**To:** Colin Kinton, PE – Beaufort County, SC  
**From:** Mark Lenters – Ourston, and Joe M. Garcia, PE – Ourston  
**Subject:** Bluffton Parkway at Bluffton Road (SC 46)  
Roundabout In-Service Review  
**Date:** February 15, 2018

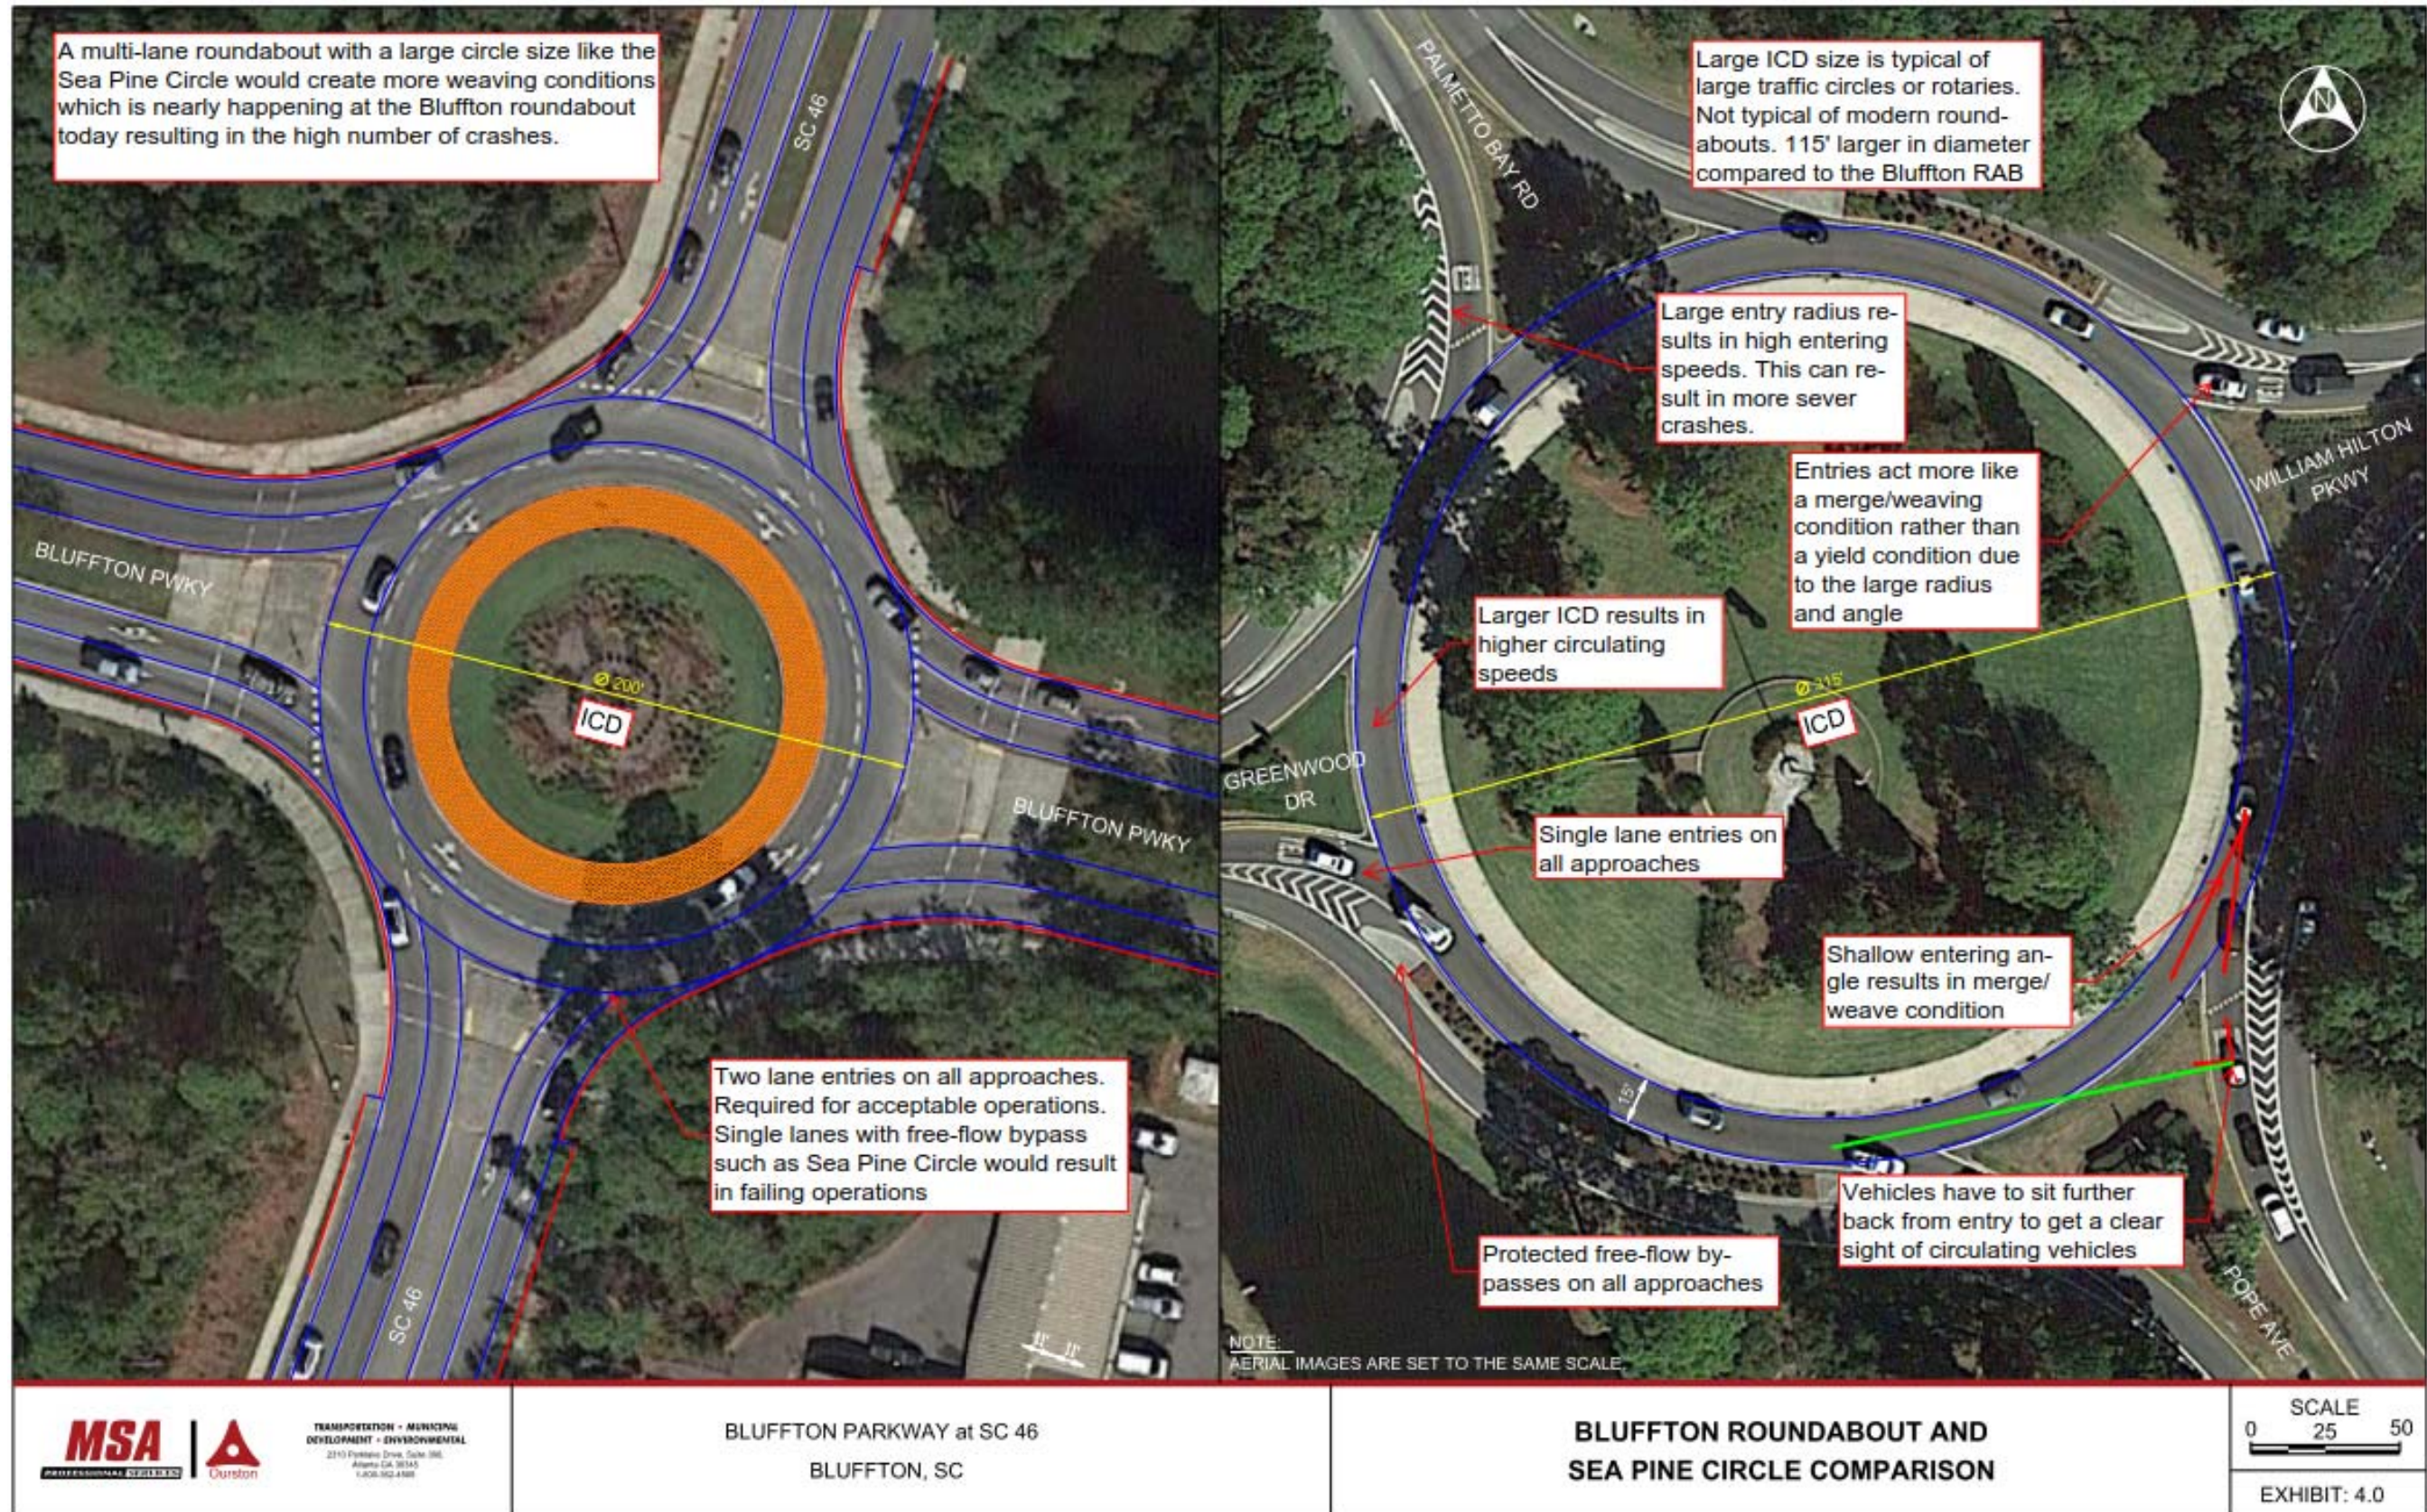
The roundabout is a radial design that is defined by approaches coming directly into the roundabout 90 degrees apart from each other. This type of design puts all of the speed control of the roundabout at the central island. This results in high entry (R1) speeds exceeding the recommend 28 MPH for multi-lane roundabouts. The circulating speed (R2) is relatively low compared to the entry speed resulting in excess braking transitioning from entering to circulating. Radial design tends to concentrate speed change on the final few feet prior to entering the roundabout, which is inadequate for drivers and contributes to excessive braking. This has been shown to contribute to failure to yield crashes. The central island controls speeds on a radial design the inscribed circle diameter (ICD) needs to be larger, in this case, the roundabout's ICD is 200 feet. Furthermore, vehicles entering the roundabout have a long conflict area and poor phi angle entering the roundabout, especially for the outside lanes. The entry angle is called the Phi angle. It is a measure of sight to the left and ease of entry to the right. These long conflict areas and fast entry speeds are likely the main reason for failure to yield crashes. Multi-lane roundabout entry and exits need to include a path overlap tangent, typically a minimum of 50 feet in length, to aid vehicles in proper lane choice. This roundabout's path overlap tangent is shorter than the 50 feet minimum, contributing to the roundabout's improper lane crash pattern. Additional geometric deficiencies are shown in Exhibit 3.0.

General Comments:  
 Entry speeds are too fast.  
 Controlling radius is too close to the entry, desirable at the crosswalk area.  
 Phi angles are shallow 10 - 7 degrees, 20 degrees desirable.  
 R1 to R2 difference in speed can result in excess braking from entry to circulating. Circulating is controlling speeds.  
 Path tangents are poor esp. for exiting vehicles.  
 Exiting radius is too tight for this size circle, could be resulting in sideswipe/imp lane change crashes.

Note:  
 Speeds indicated are geometric speeds afforded by the alignment of approaches and size of the circle.

2x1 DESIGN DIAGRAM

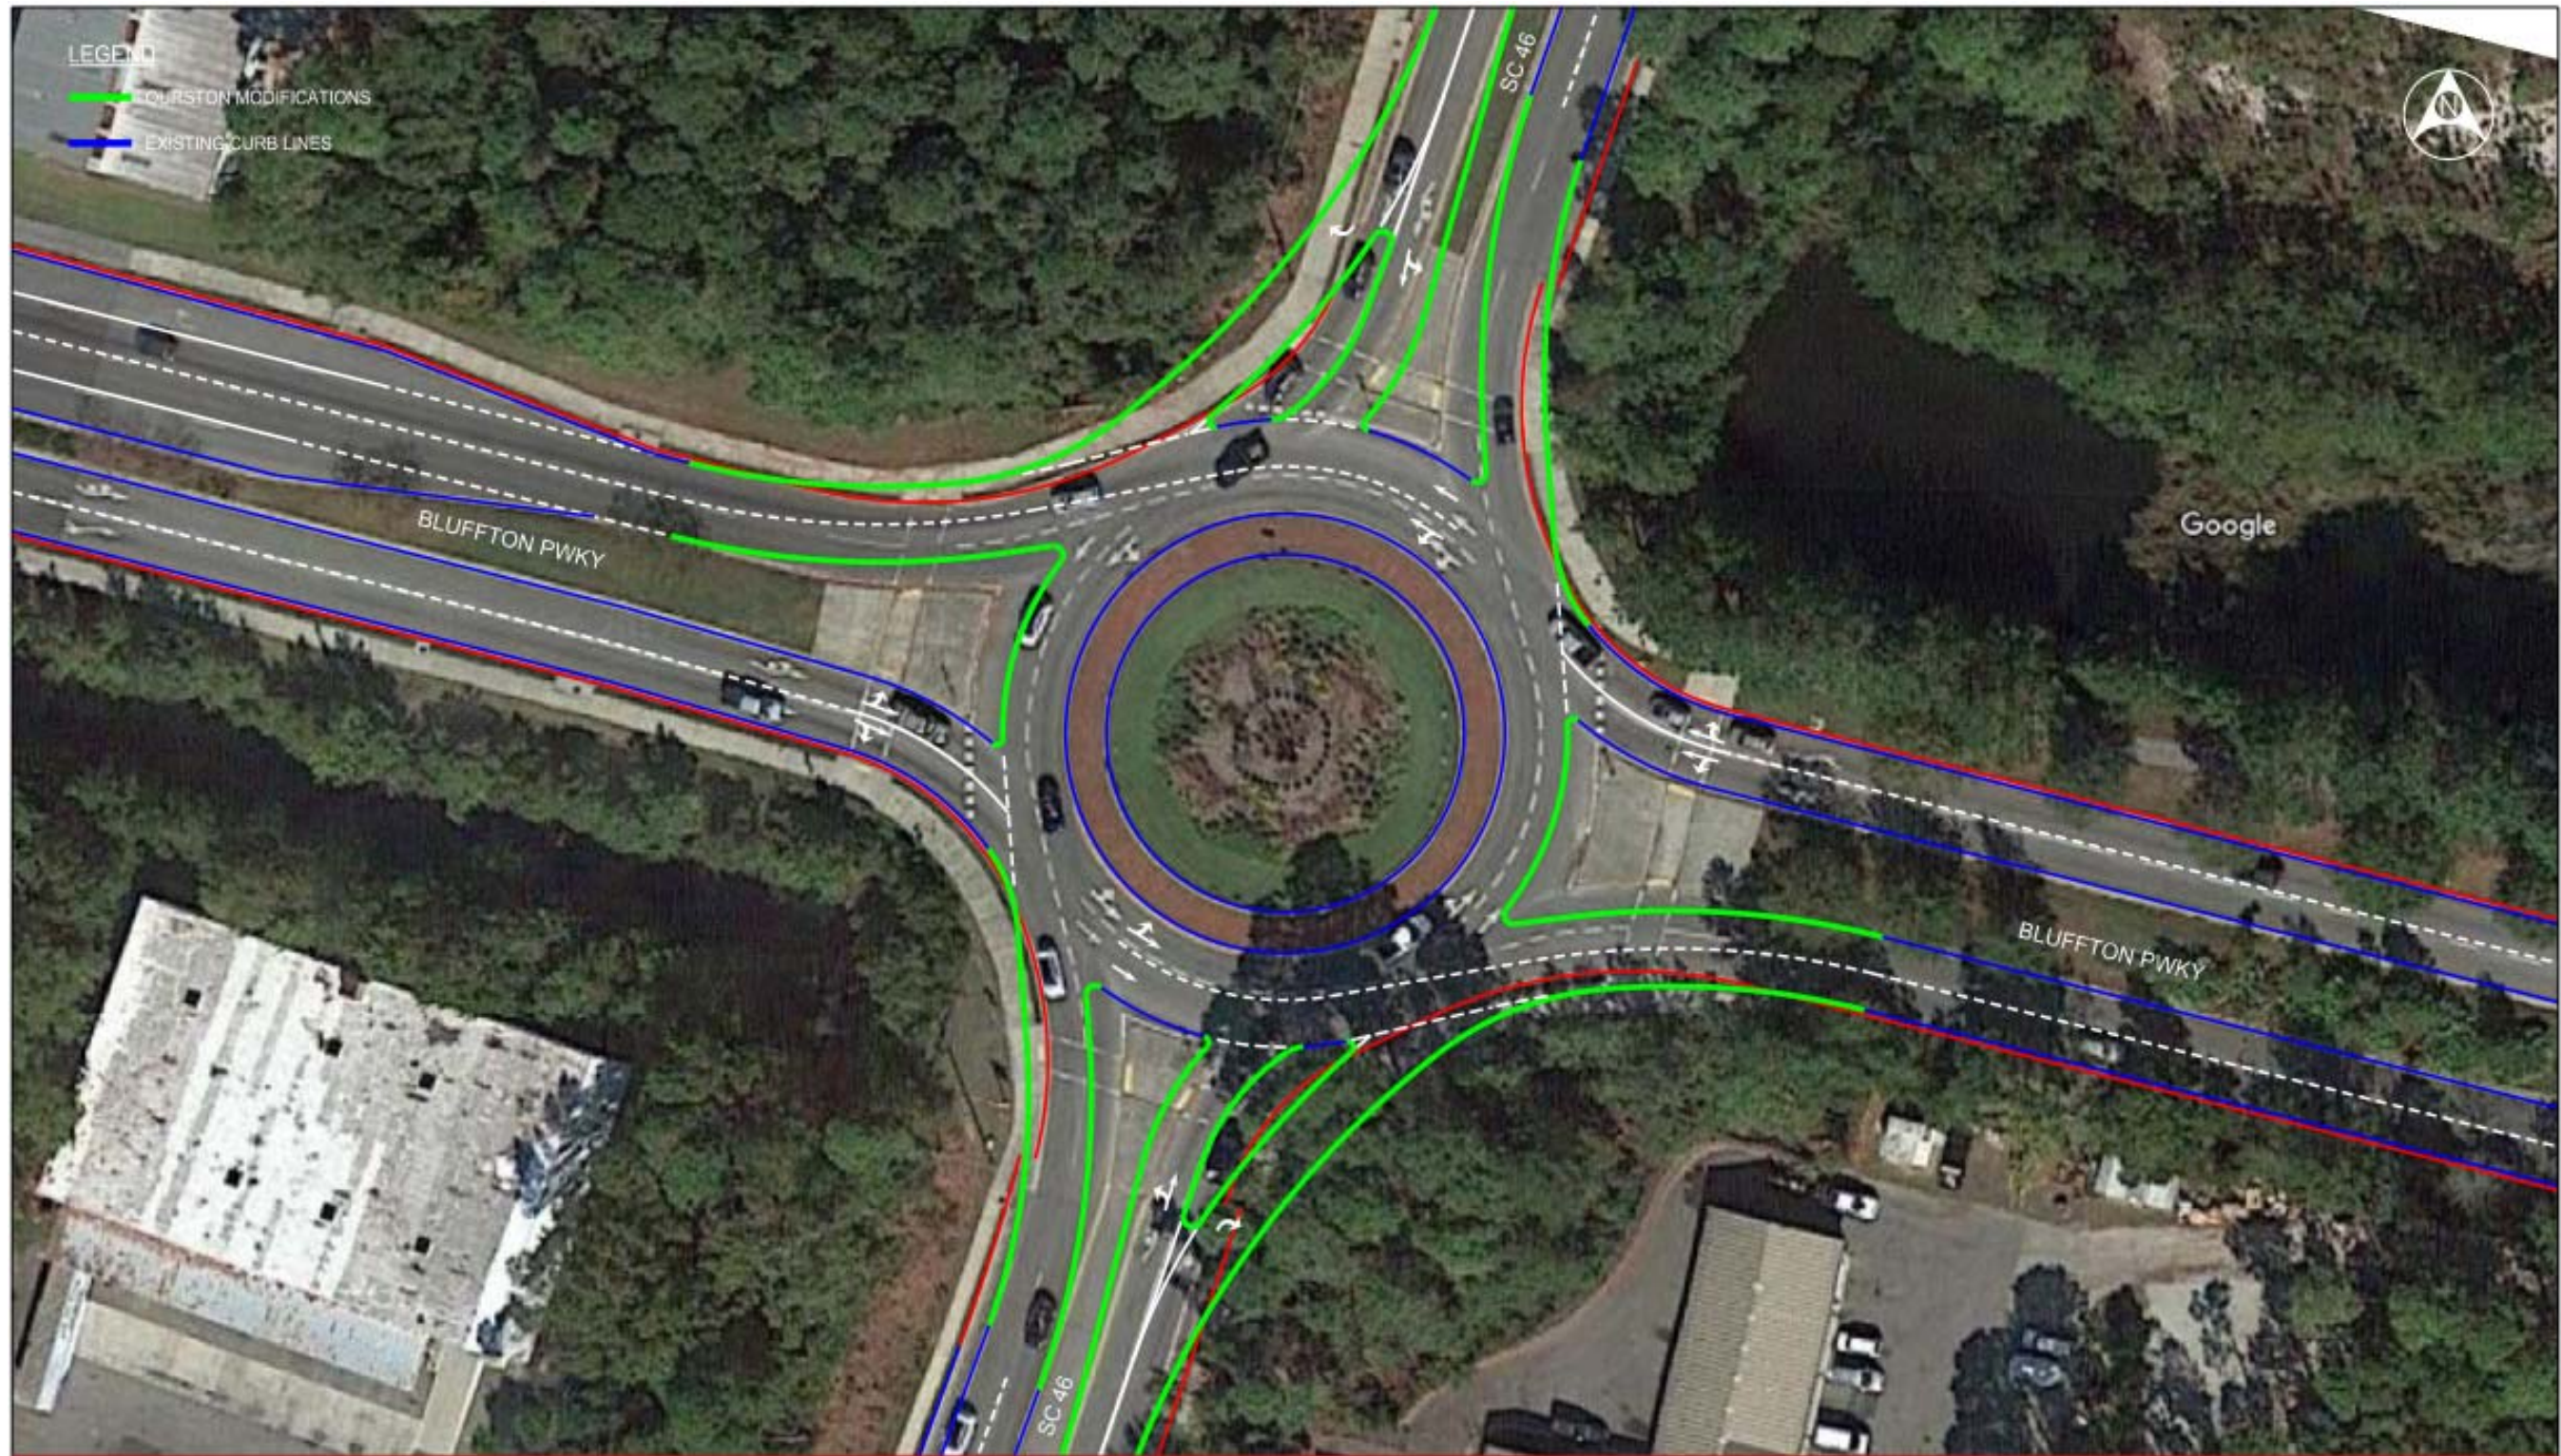
A reduction in lanes was investigated to reduce the number of conflict points. A 2x1 with northbound and southbound yielding bypasses reduces the number of conflict points in the NW and SE quadrants to half, see Exhibit 6.0. Those quadrants exhibit the highest rate of crashes. The design also incorporates improved exit tangents and gradual exit radii. The reduction in conflict area and conflict points, increased speed control on entry, and improved exit path tangents and radii is expected to reduce the complexity of gap-seeking, the failure-to-yield crashes and improper lane change crashes. A comparison of the current and 2x1 roundabout design conflict areas are shown in Exhibit 7.0.
